ADDENDUM NO. 1

Project No. 33-NBC-1007, the North Branch Pump Lateral Lining Project, Milepost 0.6 to Milepost 5.6

NORTH BRANCH PUMP LATERAL

LINING PROJECT

C-101

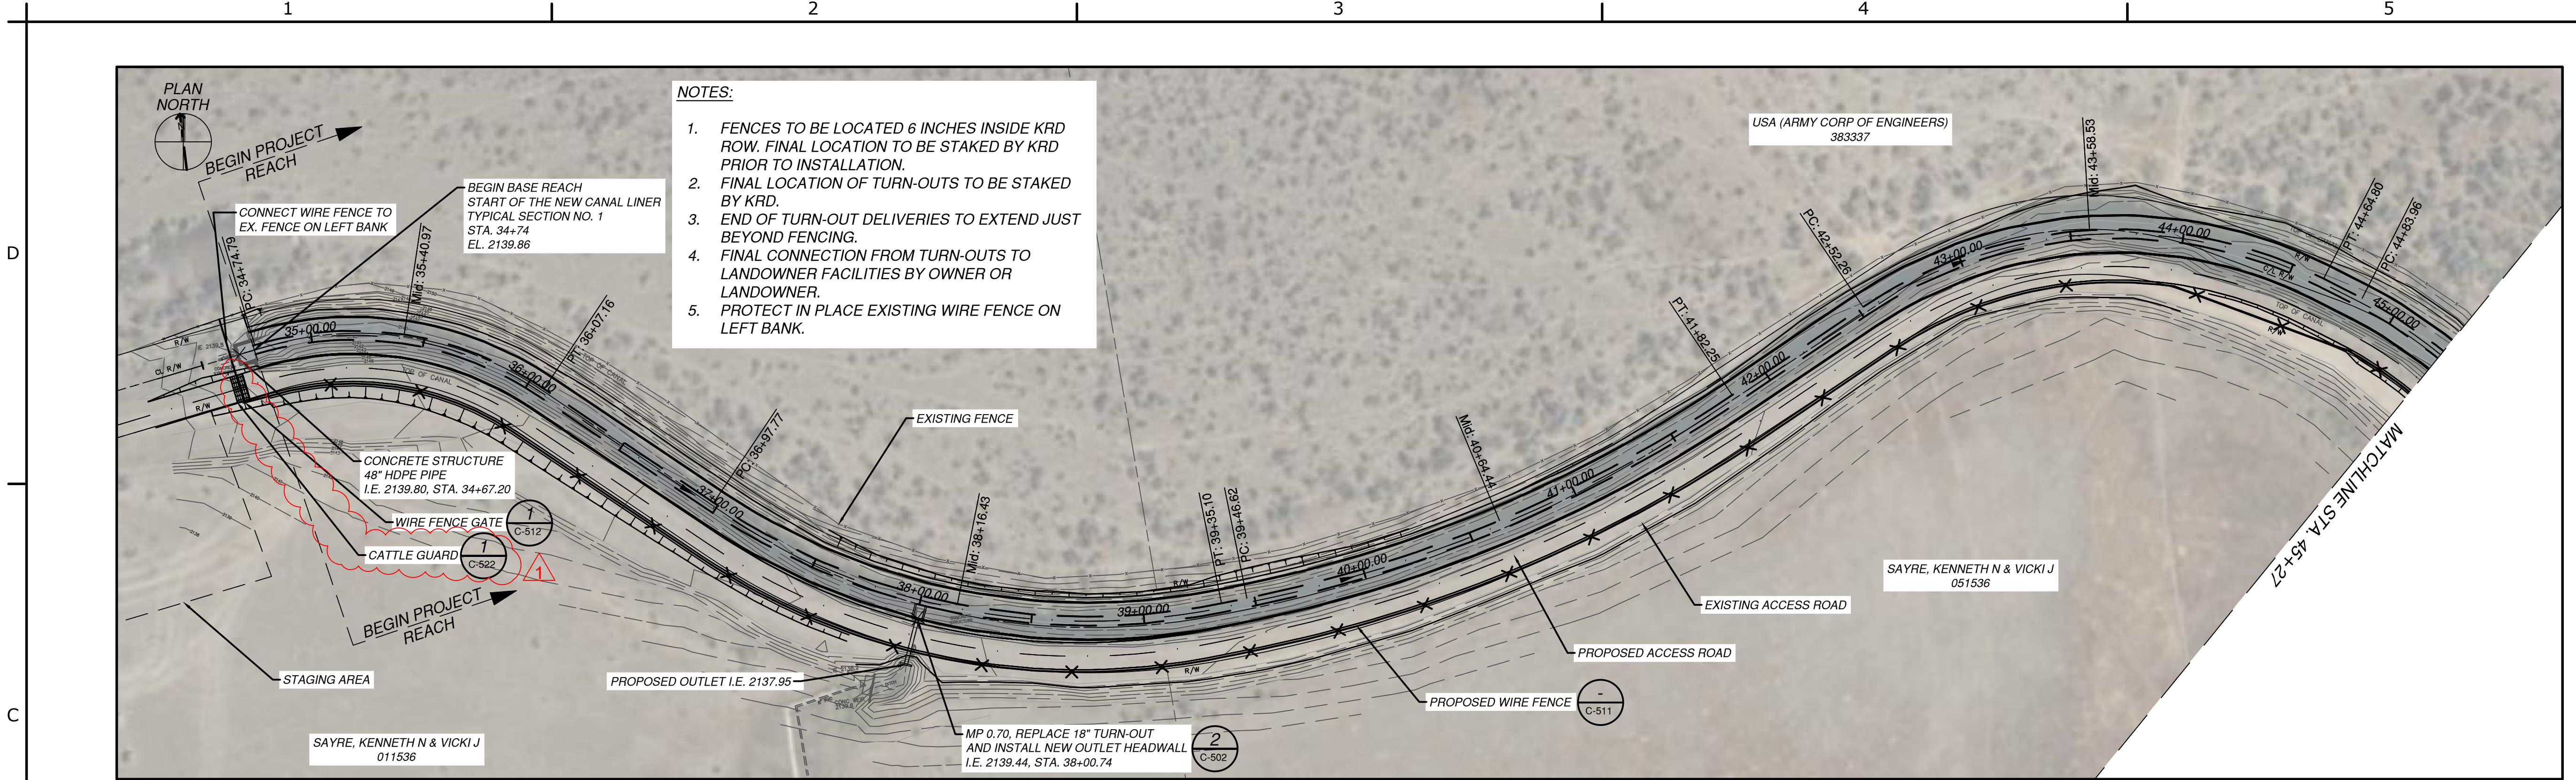
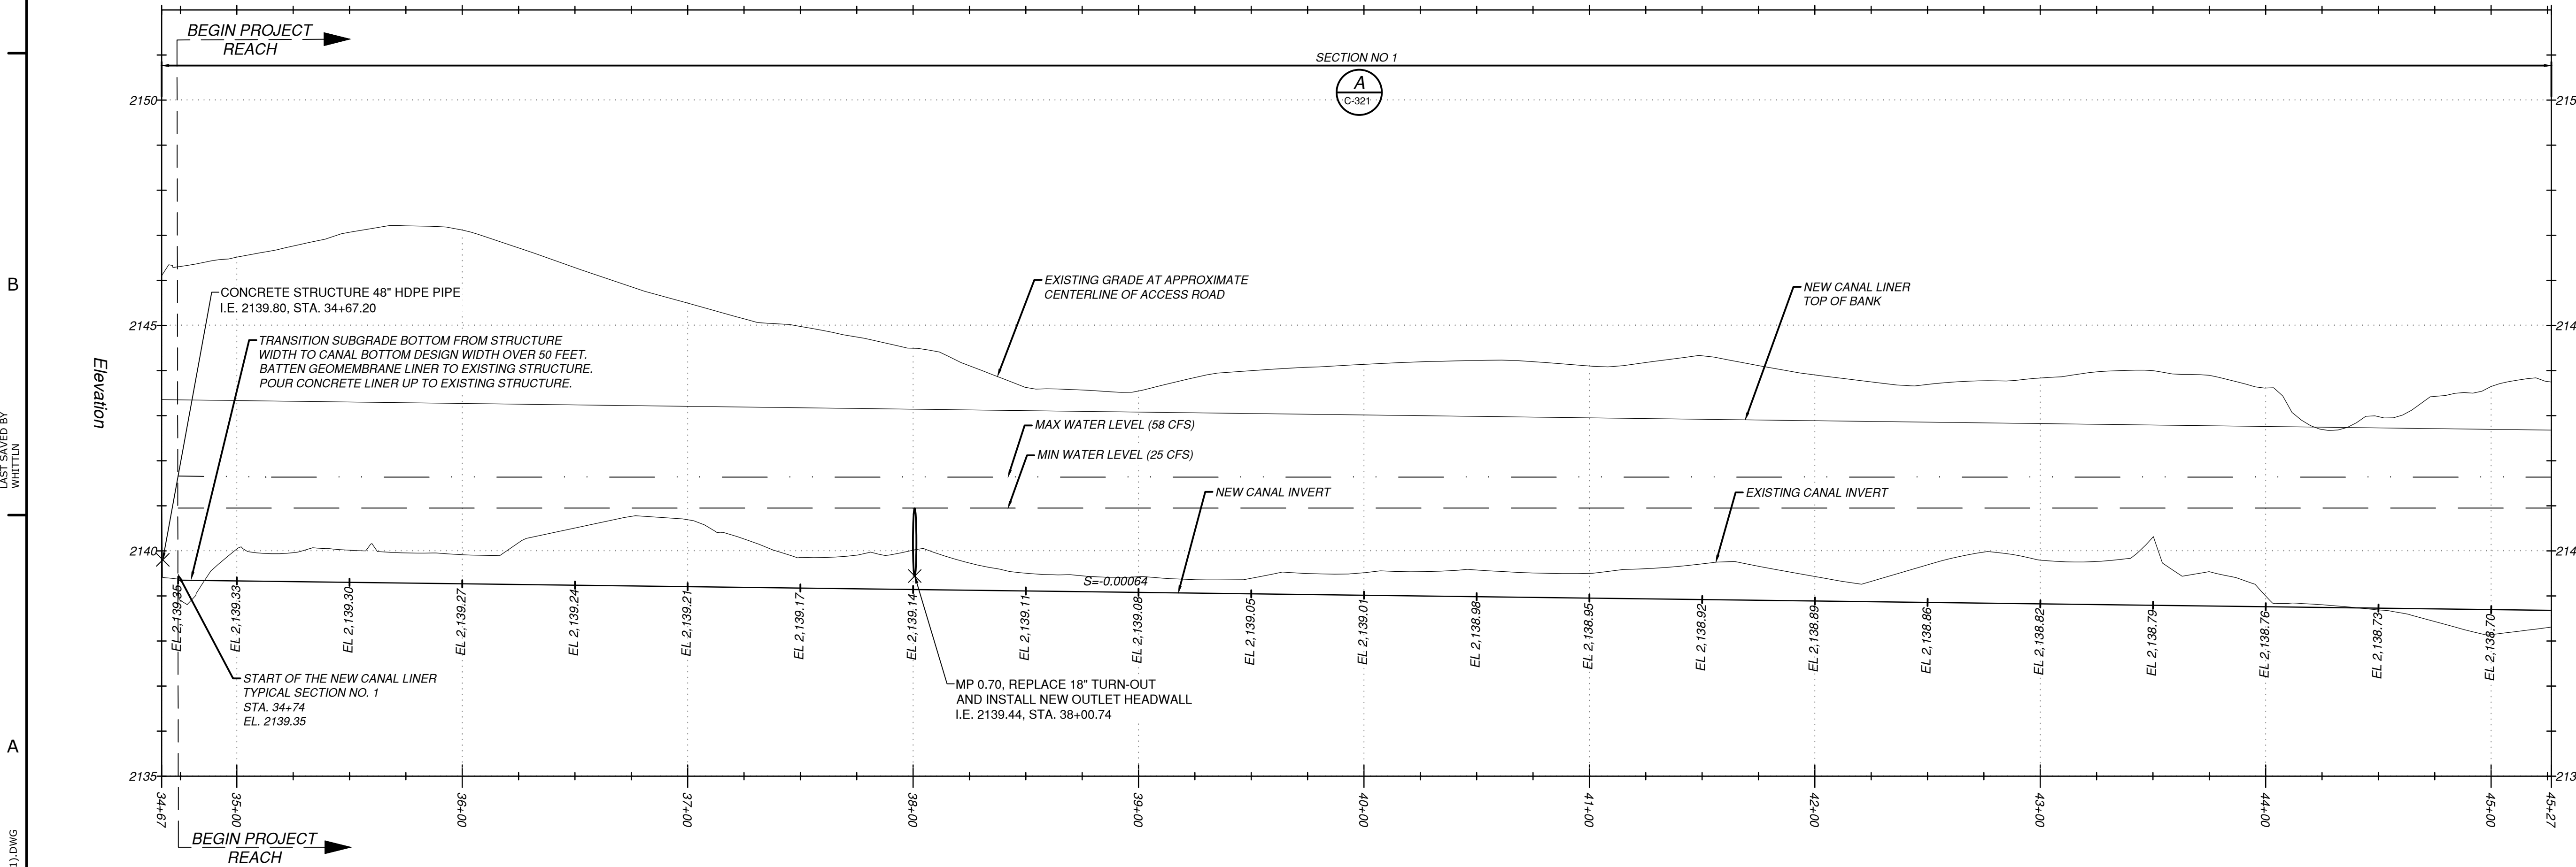
Attachment 2: Drawings C-101, C-103, C-521, and C-522

- Updated to include a permanent cattle guard at the beginning of the project (Approx. Sta. 34+65), and a temporary cattle guard at the end of the base reach (Approx. sta. 65+75).
